Re: Agnico Eagle's response to Meadowbank Gold Project 2017 Annual Report comments

The following information are intended to address the regulator's comments regarding the Meadowbank 2017 Annual Report.

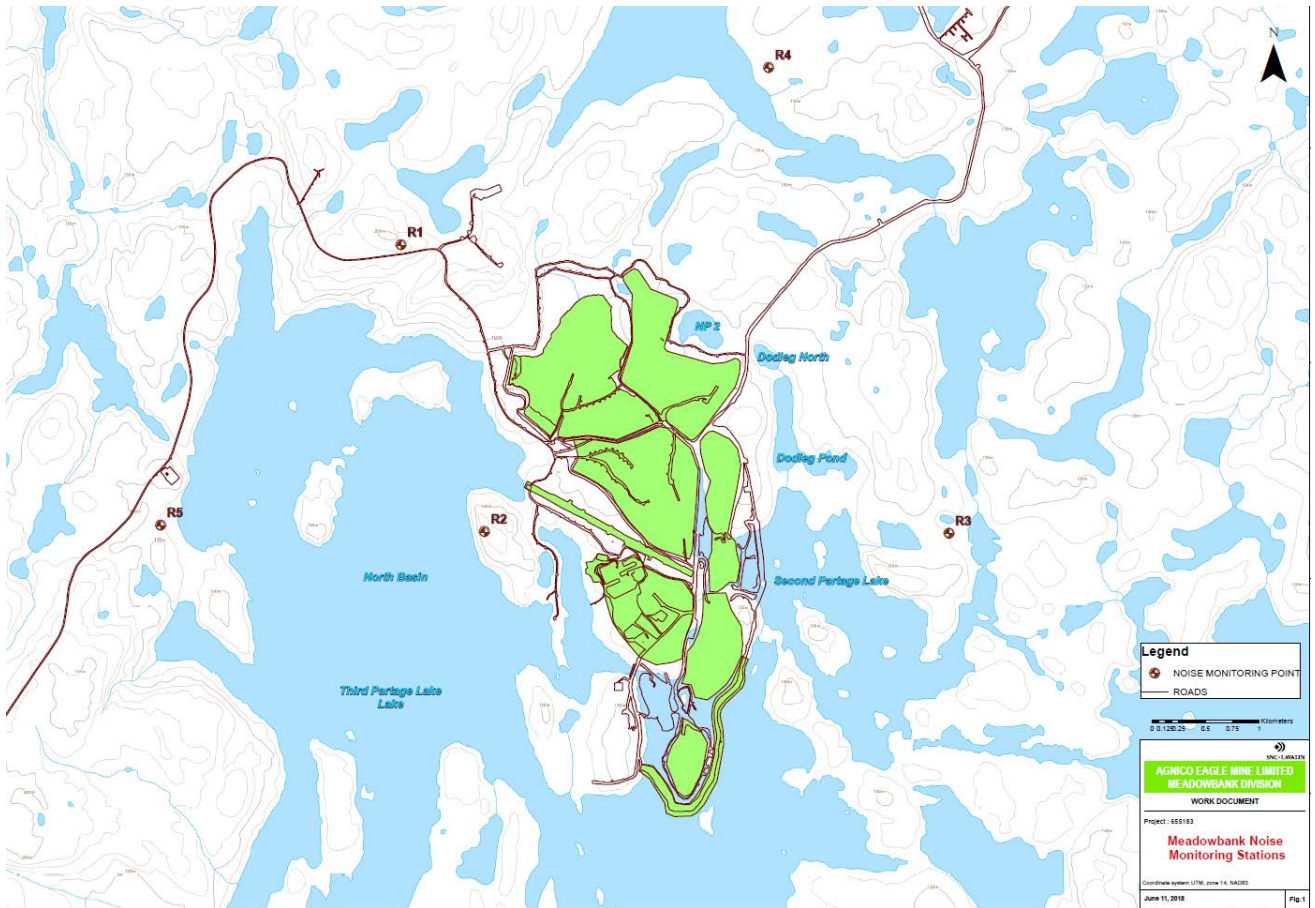
Recommendation 7: The GN recommends that the Proponent:

- 1) Provide a rationale for location selection of the receptors for noise monitoring; and

Agnico Eagle will continue to monitor noise levels around the Meadowbank mine site at five locations previously determined in consultation with Golder Associates Ltd. Figure below show the noise monitoring location in relation to the mine site features. All sites are located at a distance from noise sources to be representative of sound levels in locations where wildlife may be expected to occur, and where noise-related PPE is not required. The measured levels provide a snapshot of the acoustic environment in this phase of project and are considered representative of the current operational activity.

The below graphic represented Figure 38 of the 2017 Annual Report.

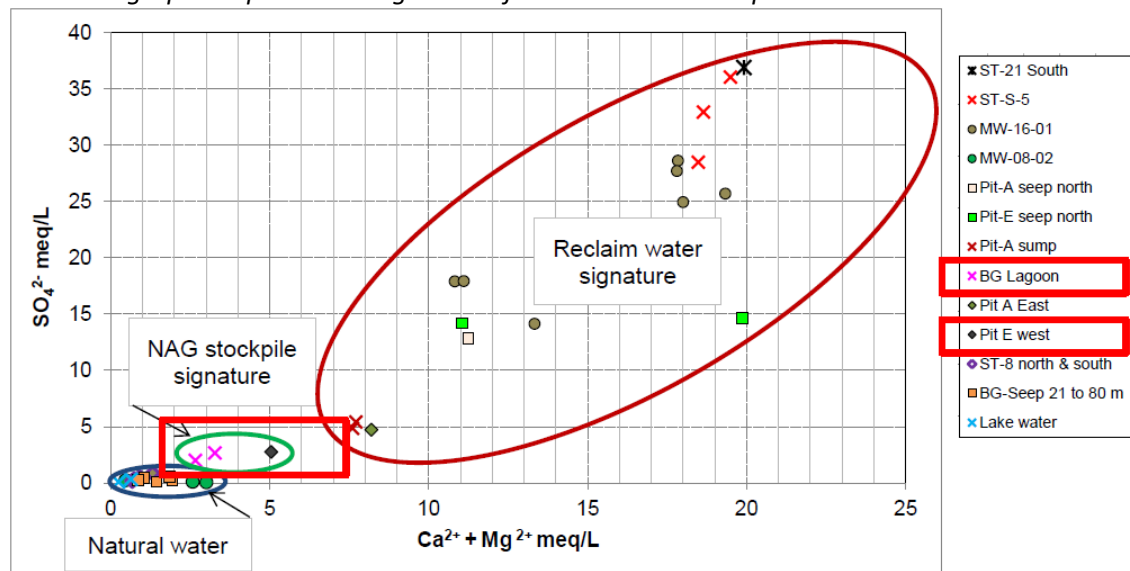
Concern: Figure 38 of the 2017 Annual Report summarizes sulphate concentrations vs. calcium plus magnesium concentrations measured in various groundwater or potential groundwater sources, and identifies three types of water: Reclaim Water, NAG Stockpile, and Natural Water. However, when the various water signatures are discussed in the text on page 161 of the Report, the signature associated with waste rock is identified as being from the Potentially Acid Generating (PAG) Stockpile and not NAG. The same discrepancy is noted in the 2017 Groundwater Monitoring Program Report.

Recommendation 21: CIRNAC recommends that AEM should clarify whether the signature is for PAG or NAG waste rock seepage.

It was suggested within Figure 38 of the 2017 Annual Report that three (3) possible signatures were identified in 2017 groundwater related samples. They were showed and separated according to chemical ratios and possible source identified, for example NAG

stockpiles are located in the vicinity of the locations (BG Lagoon and Pit E West) identified under NAG stockpile signature. A hypothesis was formulated that this water enters in contact with the rocks and dust and can eventually leach with a signature from either (NAG or PAG). This rationale was meant to explain why sulfate vs calcium + magnesium was plotting a little higher on the graph when compared with background groundwater samples. This hypothesis has not been confirmed as other factors could influence those variations. The proximity of the signature comparison the natural water meant that focus could be shifted to other elements.

Thus it was mentioned in the text on page 161 that three potential groups could be further interpreted on site:

4.15 Section 7: Spill Management - Landfarm

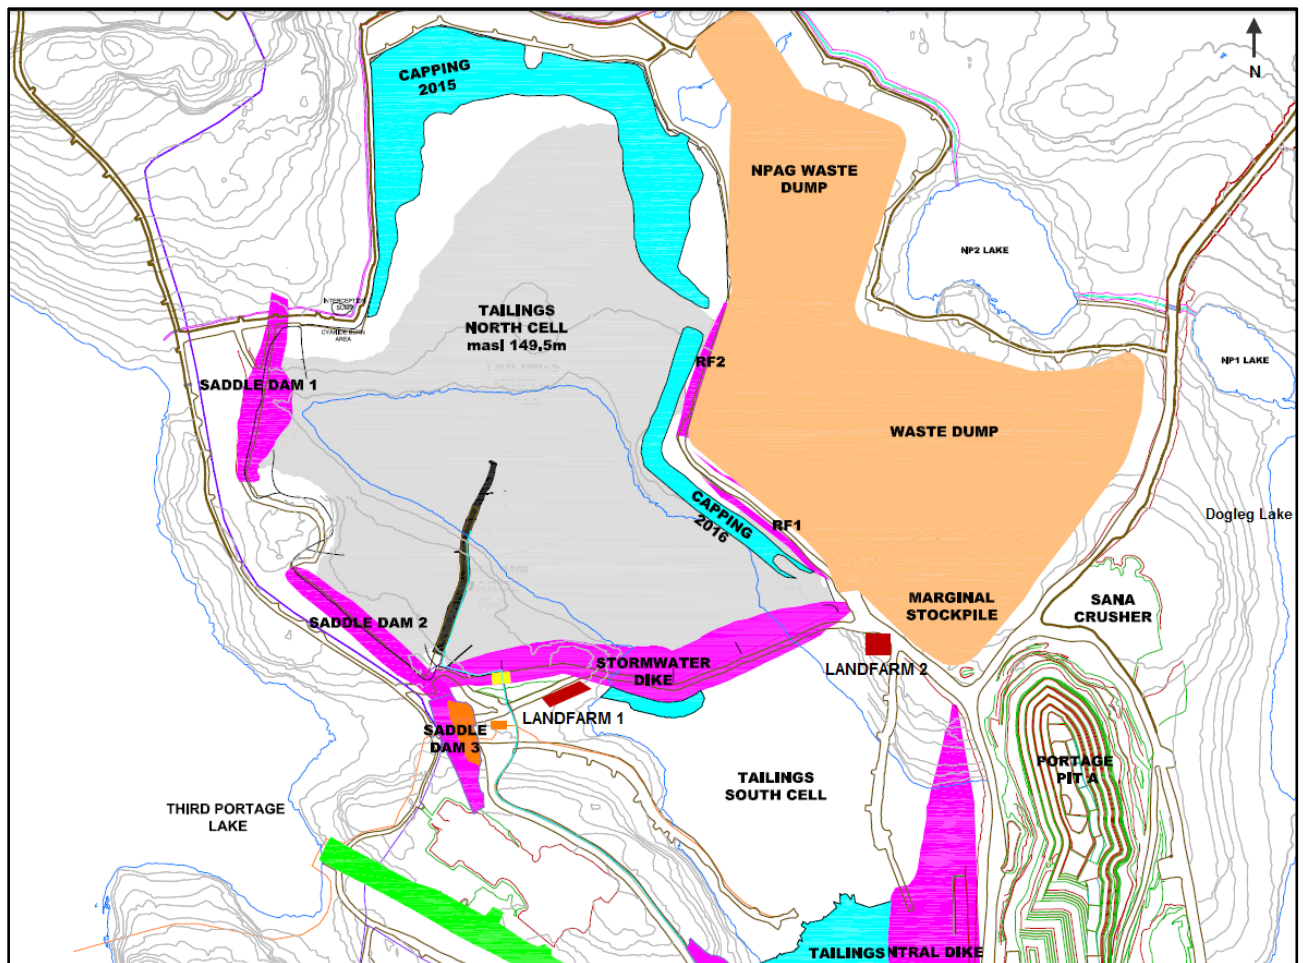
Concern: AEM decided to find a new location for the landfarm (Landfarm 2) to continue treatment of contaminated soil, since the existing landfarm (Landfarm 1) is located on the northwest side of the South Tailings Cell, and will eventually be flooded by reclaim water; Landfarm 2 was constructed in 2016. An extension of Landfarm 1 was also built at a higher elevation in 2016 to continue treatment of soil at this location. AEM does not indicate where the newly constructed Landfarm 2 is located. AEM reports the amount of soil added to Landfarm 2 from September 2016 to January 2017. Was any additional soil added to Landfarm 2 in the remainder of 2017?

Recommendation 32: Please indicate the location of Landfarm 2.

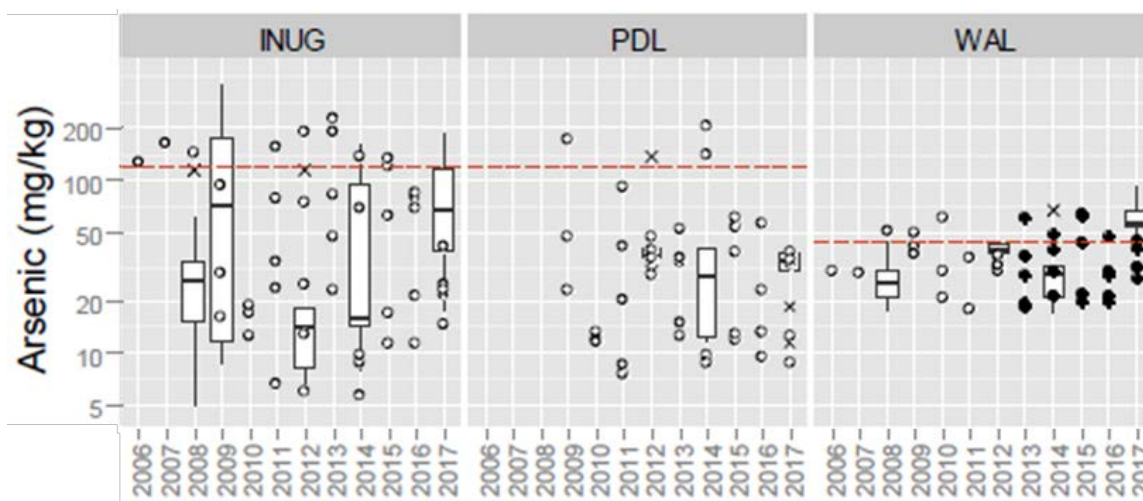
Concern: Wally Lake had trigger exceedances in lead, chromium and arsenic in 2017 sediment samples. While lead and chromium were "marginally above their respective trigger values" (p. 136), arsenic was approximately 2.5 times higher than baseline and had increased since the previous coring sample was collected in 2014. AEM suggests that this trend may be due to natural spatial heterogeneity but is not affecting benthic richness or abundance according to the 2017 BACI analysis. AEM recommends that coring continue in 2018 to determine whether the increasing trend is real or related to spatial heterogeneity, and that a targeted bioavailability study also be conducted to determine potential effects on biotic communities. We agree with these recommendations for further study of the issue. However, we are not clear on how additional coring will resolve whether the arsenic trend is mine-related or due to spatial heterogeneity. How would elevated arsenic levels reflect spatial heterogeneity if they represent an increase from baseline levels collected at the same location? Furthermore, it is not clear whether AEM has established medium and high level triggers that require additional action if levels of these parameters continue to increase. This should be completed in response to triggering a low action level response.

Recommendation 41: Please explain how additional coring will be used to distinguish between mine related and background variation in arsenic values at Wally Lake. Please also clarify the potential influence of spatial heterogeneity on variation in arsenic levels.

This region is highly mineralized and metals concentrations in sediment from the Meadowbank project lakes can be quite variable over a small spatial area within the

prescribed sampling areas. Coring is undertaken at the same general locations within the sediment basin (8 m +/- 1.5 m) to minimize the potential confounding effects of spatial variability in sediment metals concentrations, but even on the scale of 10-20 m, sediment metals concentrations are not homogenous. This phenomenon is exemplified by the patterns observed for arsenic at reference areas INUG and PDL (see figure below, excerpted from 2017 CREMP Figure 3.2-55). Coring (box and whiskers) conducted in 2009 at INUG first highlighted this challenge. Since then, coring results at INUG have continued to be quite variable, but largely been consistent with the range observed across the annual grab samples (open circles for baseline/reference data; black circles for “after” data). Highly variable arsenic results have also been observed at PDL, but less so for the coring results. While the 2017 coring results at Wally show an apparent increase in arsenic relative to 2014, the overall pattern is more suggestive of natural variability (e.g., to what was observed at INUG and PDL) than of mine-related changes (e.g., chromium at TPE); similar differences were observed between two baseline coring events (2008 and 2012) and the most recent coring results are largely consistent with historical data.
